# 11. COA-061566-2019

# Commission of Architectural Review

## STAFF REPORT

**Construct a new multi-family residence on a vacant lot.**

Figure 1. 1905 Sanborn map

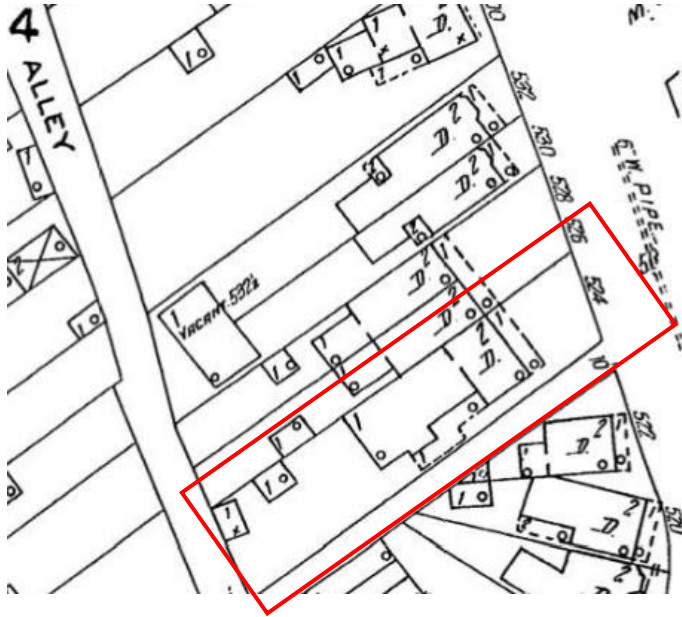
According to the site plan, the proposed building will be set back further from the street than the adjacent double house. It appears that the front of the porch will align with the face of the adjacent buildings. Historic photographs and Sanborn maps indicate that historically the former house on this site and the adjacent double house were aligned and had a deeper setback than other houses on the block. The proposed building is set back further than the former house on this site and what is typical for this urban area. Staff recommends that the new construction be aligned with the adjacent dwellings.

- the new construction be aligned with the adjacent dwellings
